## Certificate of Appropriateness

Filing Date: March 12, 2024  
Case Number: **24-08-HPC**  
Request: **Certificate of Appropriateness**  
Project Address: 908 Rutherford St. Shreveport, LA 71104 Historic District:  
Fairfield Historic District  
Zoning: R-HU  
Applicant: Clarence Babineaux, SGB Architects, LLC  
[clarence@sgba.com](mailto:clarence@sgba.com)  
MPC Review by: Adam Bailey, Community Planning and Design Manager  
[adam.bailey@shreveportla.gov](mailto:adam.bailey@shreveportla.gov)  
HPC Meeting Date: March 19, 2024

The applicant would like permission to "construct 8 columbaria to house 48 niches, each, to be located in the 'The Family Garden,' which is the courtyard bounded by the Cathedral, the Parish House, and the School."<sup>2</sup>

Figure 4. St. Mark's – Existing Columbarium of the north wall of the Cathedral.

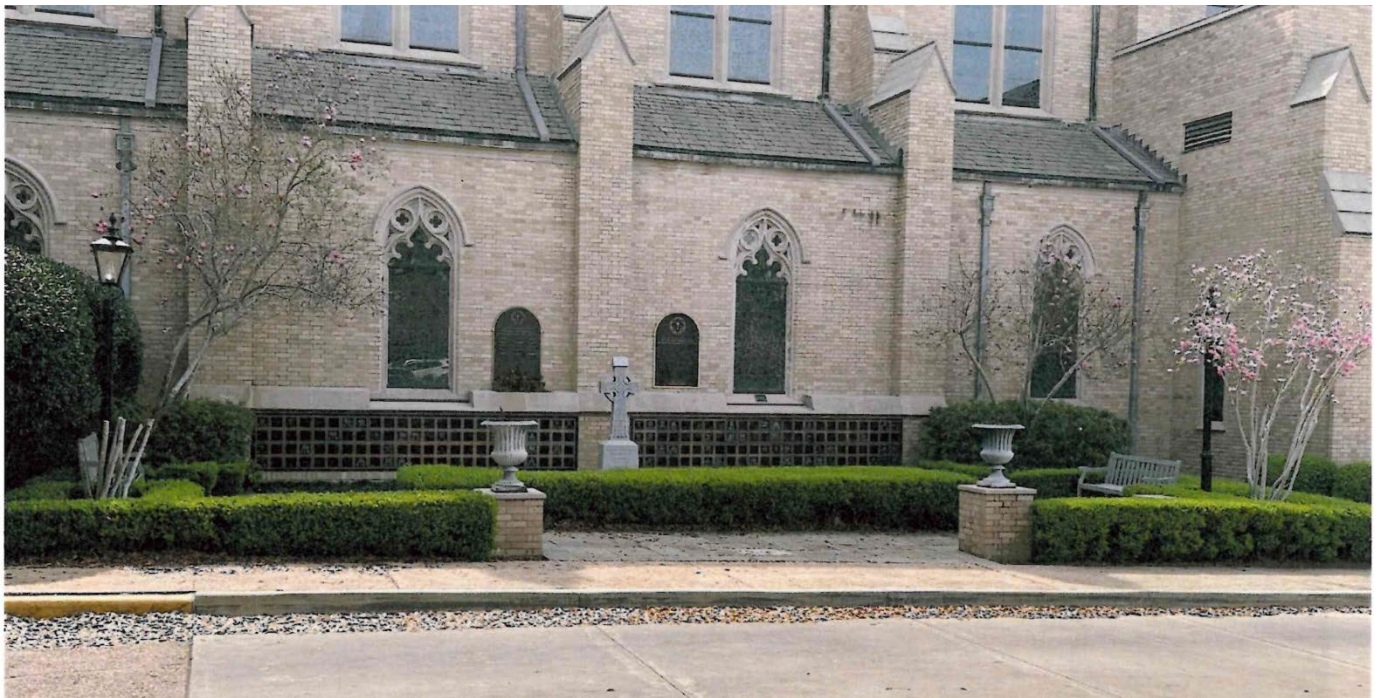
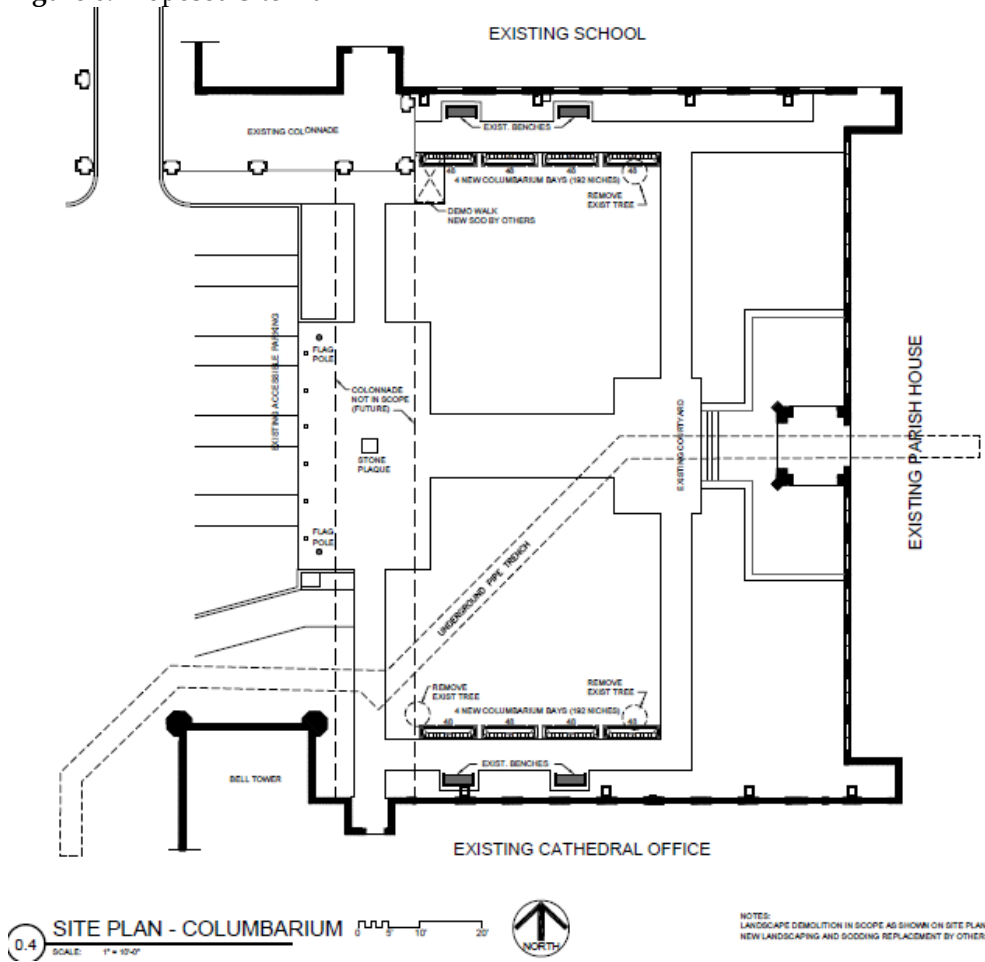
**MPC STAFF COMMENTS: MPC staff finds that the proposed improvements are HARMONIOUS with the special character of the HPOD.** The proposed columbarium will match the style and color of the existing columbarium. See Figures 1-5 for existing site photographs; See Figure 6 for Proposed Site Plan; See Renderings 1-3 for Proposed Columbarium.

**MPC STAFF COMMENTS: MPC staff finds that the proposed improvements WILL NOT adversely affect the historic character of the landmark, site, building, structure, landscape, and/or object.** The proposed columbarium will match the style and color of the existing columbarium that currently occupies the courtyard. See Figures 1-5 for existing site photographs; See Figure 6 for Proposed Site Plan; See Renderings 1-3 for Proposed Columbarium.
